DRAINAGE LETTER
FOR
STERLING RANCH ROAD AND BRIARGATE PARKWAY INTERIM PLAN

May 2022
Project No. 25188.03
PCD Filing No: CDR221

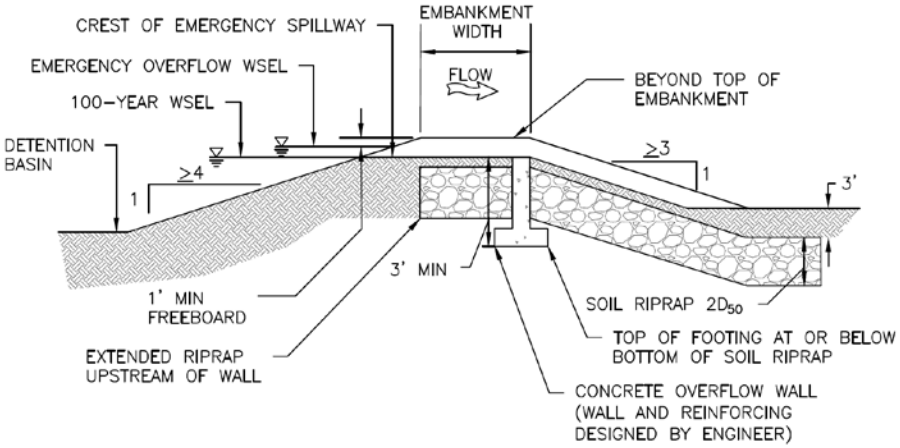
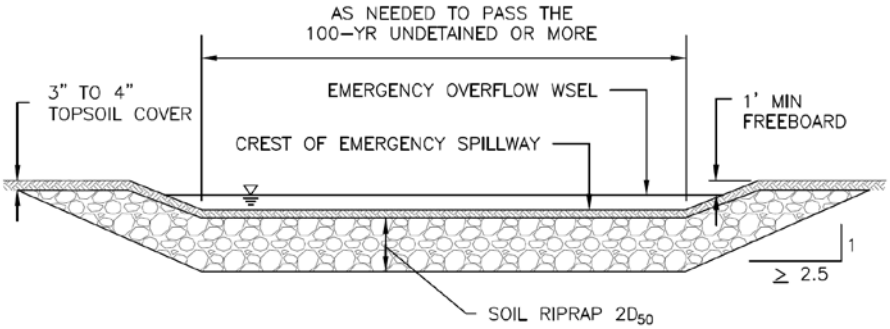
Change to Interim Pond FSD16

JR RESPONDED: POND REMOVED AS NO LONGER NEEDED

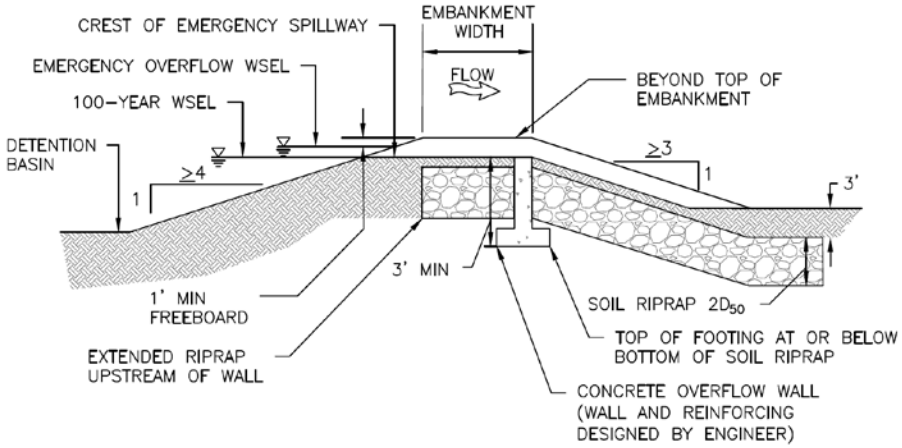
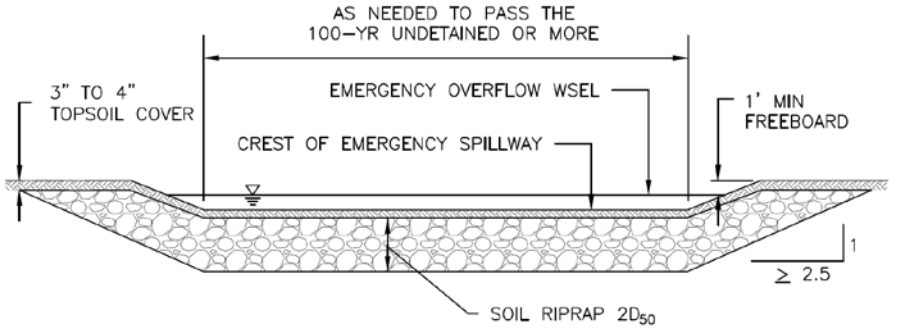
Change to Interim Pond FSD14A

JR RESPONDED: POND REMOVED AS NO LONGER NEEDED

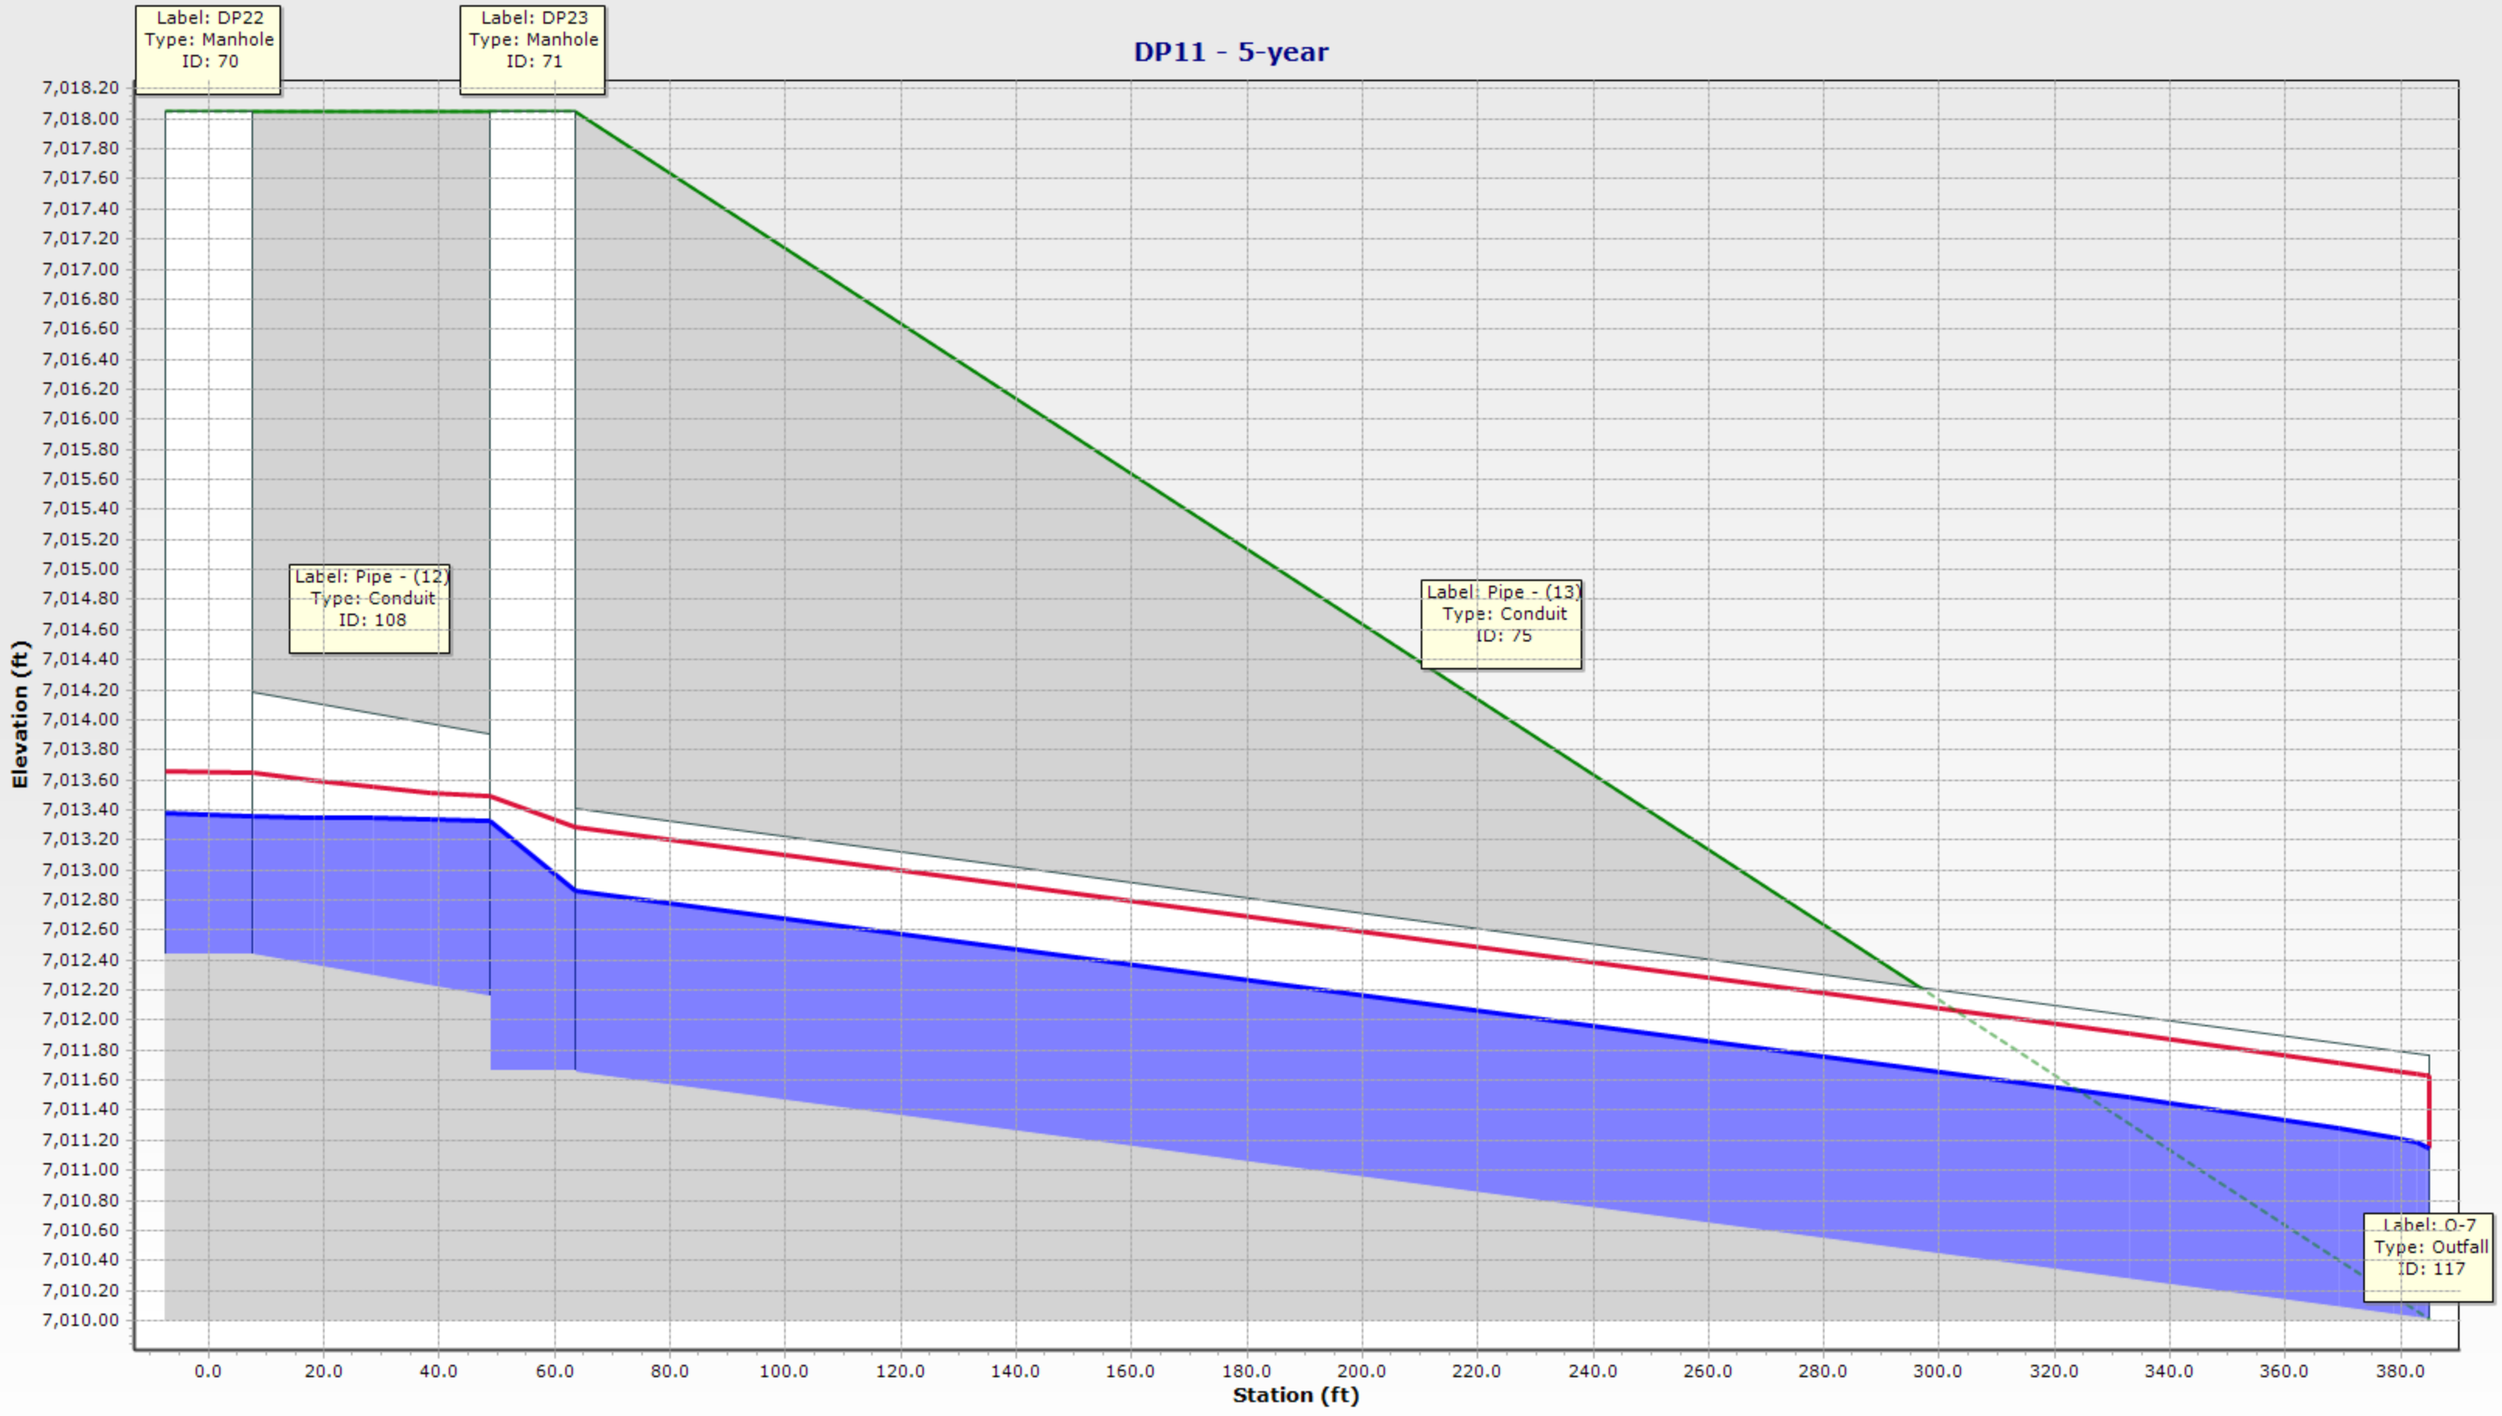
Pipe size does not match plans or drainage map. Please revise to 24".

JR RESPONSE: PIPES 12 AND 13 UPDATED TO 24"

Worksheet for Proposed Swale - Cross Section CC

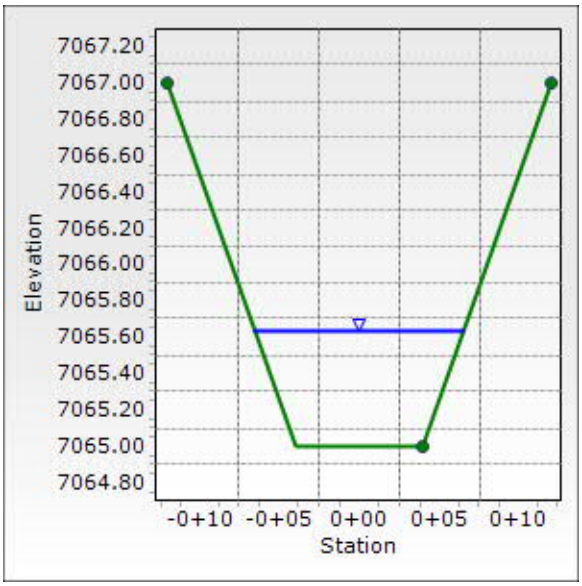
Detail on drainage map shows 5' bottom, this shows an 8' bottom. Please reconcile between all documents and update.

JR RESPONSE: UPDATED TO SHWO 5' BOTTOM WITH 4:1 SIDE SLOPES

Worksheet for Proposed Swale - Cross Section EE

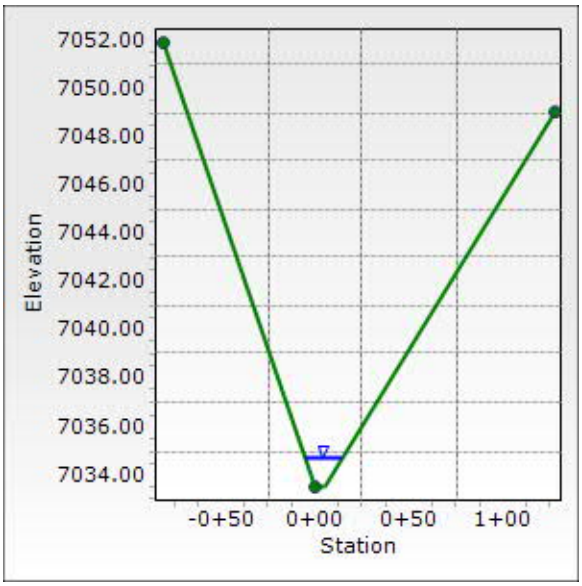
This works out closer to an 8:1 side slope. Detail on drainage map shows 4:1. Please reconcile between documents and revise

JR RESPONSE: UPDATED TO 5" BOTTOM AND 4:1 SIDE SLOPES

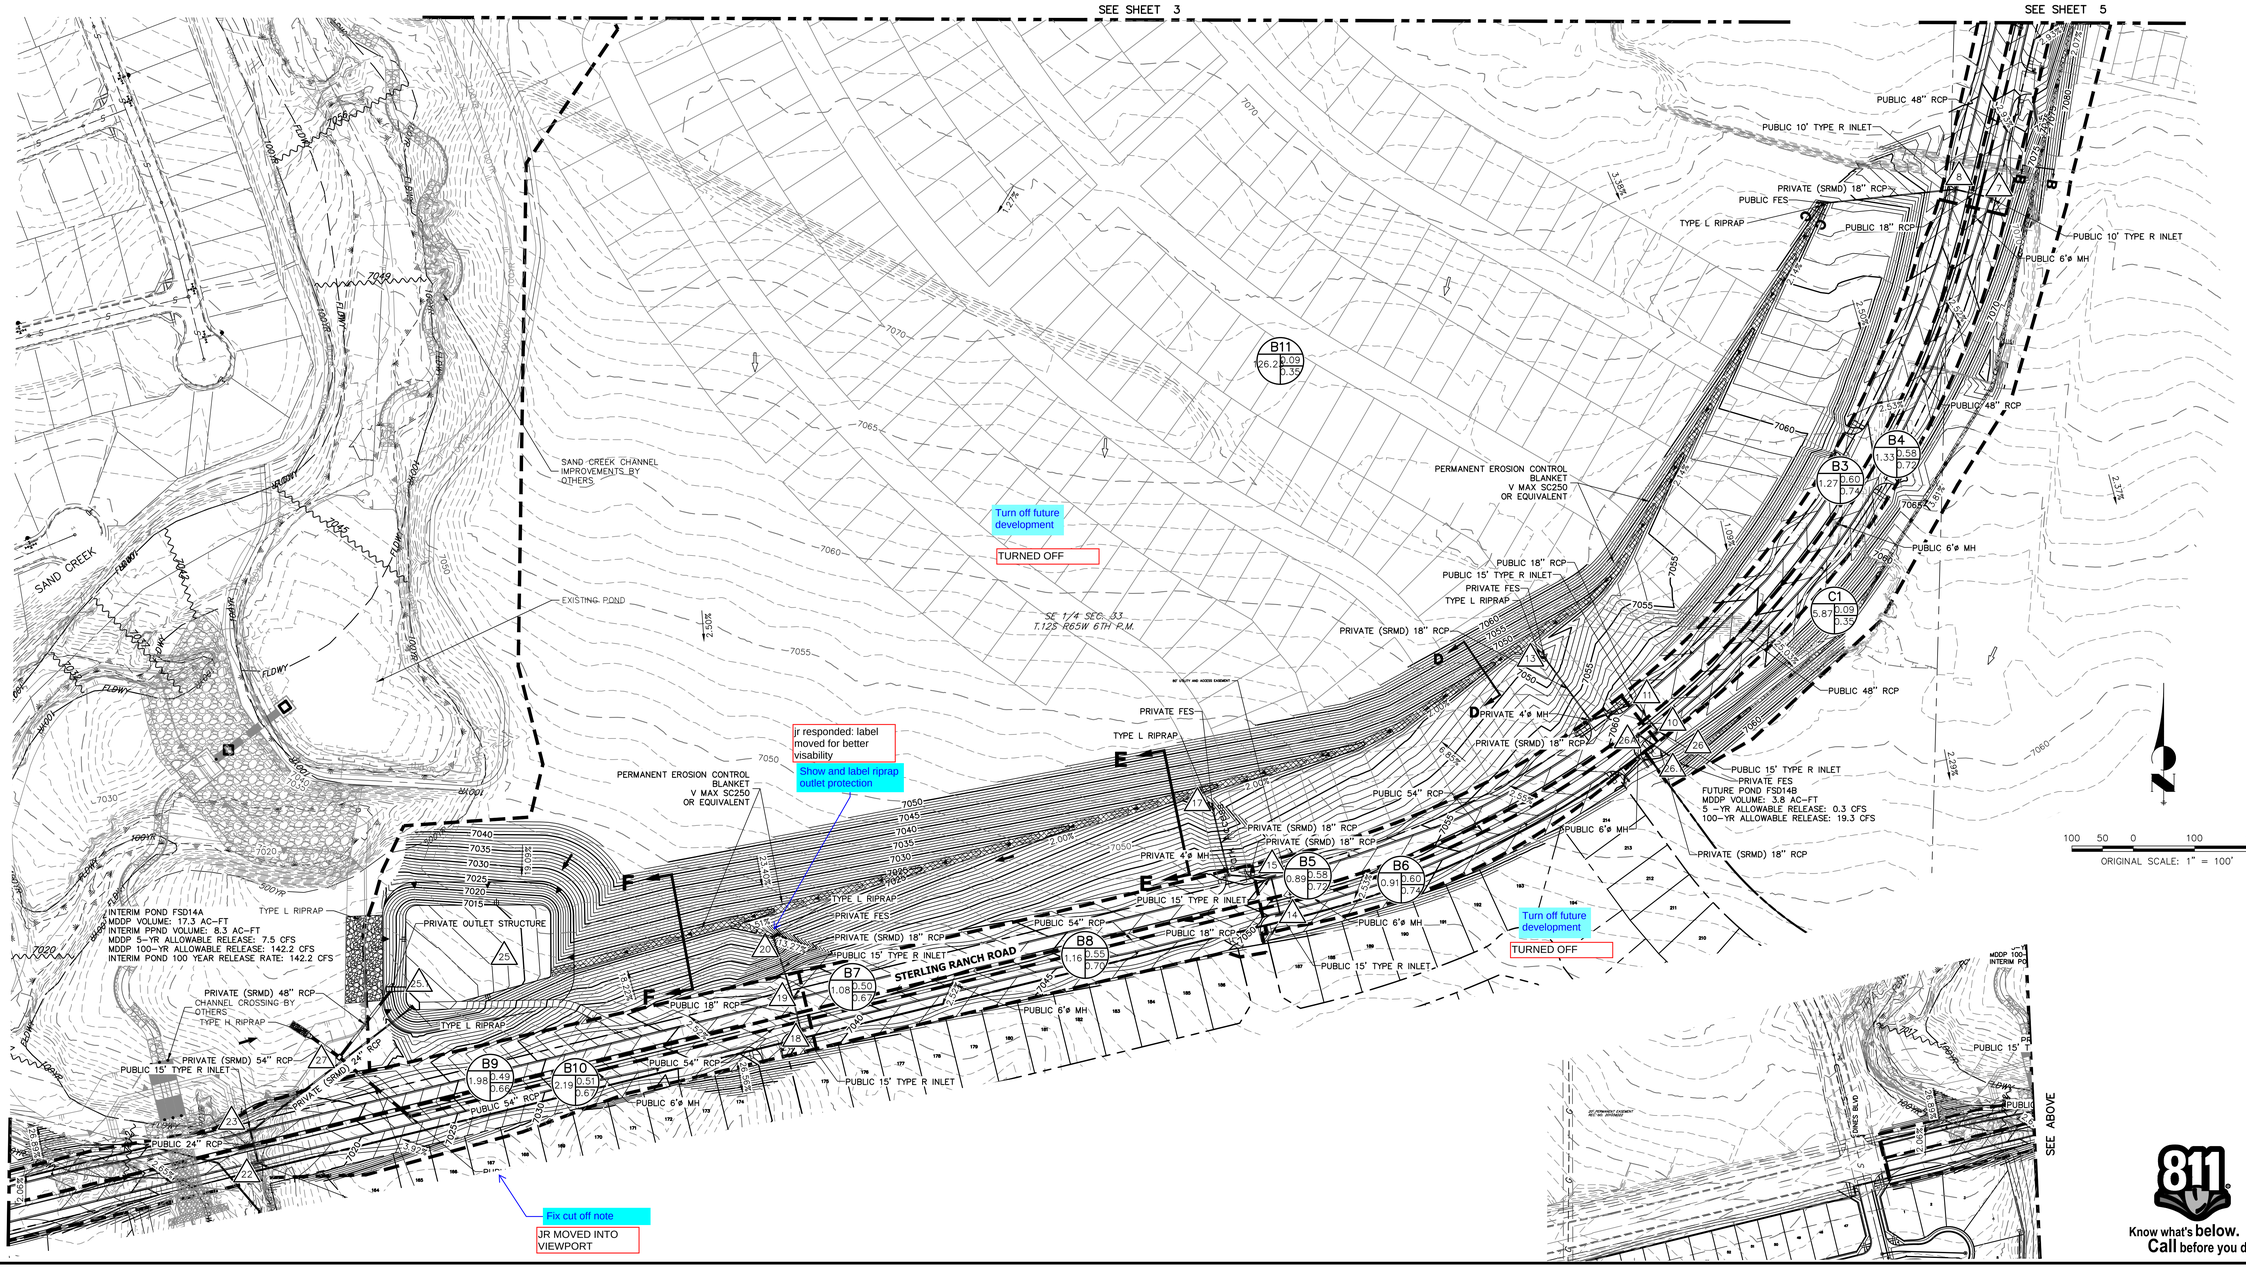
Turn off future development

Show and label riprap outlet protection

TURNED OFF
